Westinghouse Signal LED Module Failure

Applicability

ARTC Network Wide	✓
-------------------	---

Figure 1

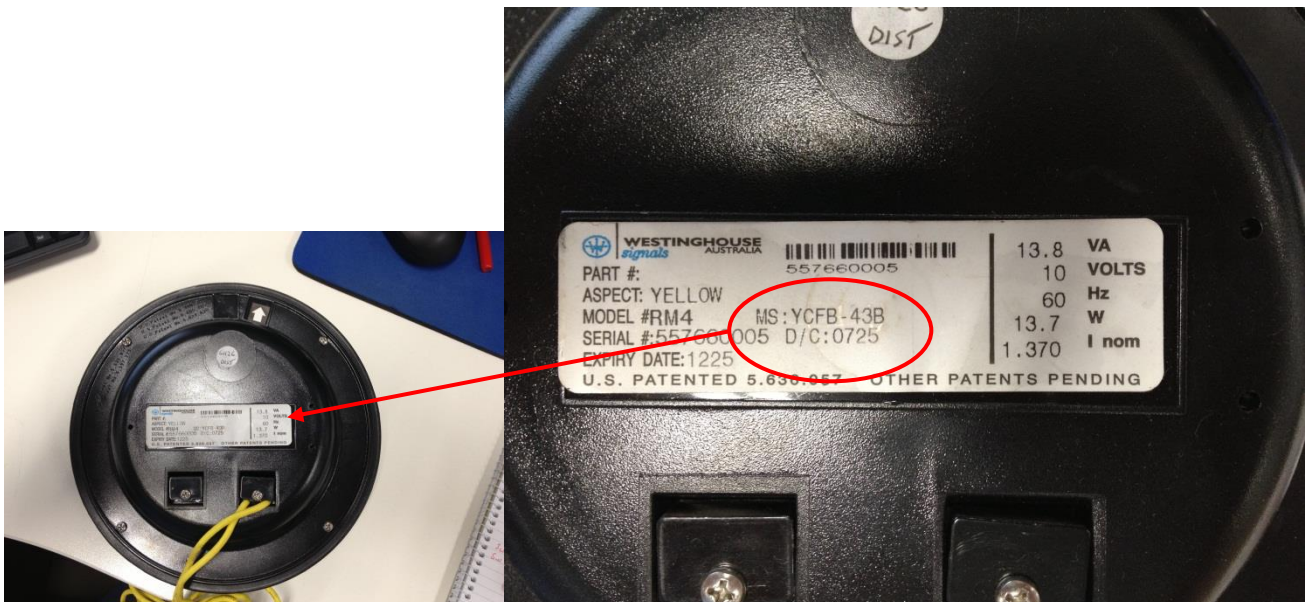
- 1) Inspect the Information Label fixed to the rear of the RM4 LED module (as shown in Figure1)
- 2) If the D/C (Date of Construction) number is lower / earlier than 0741 (41st week of 2007) then record the interlocking location name e.g. crossing loop name, signal number, date as shown on the label and the signal aspect i.e. Red, Yellow or Green and if the Yellow aspect has a pulsating Yellow function on the form provided in the appendix.

- 3) For YELLOW aspects the LED module should be replaced immediately or recorded as a defect and scheduled for replacement (provided sufficient spares maintained in inventory) in the Works Management System (WMS) at the earliest opportunity but no later than the next maintenance visit.
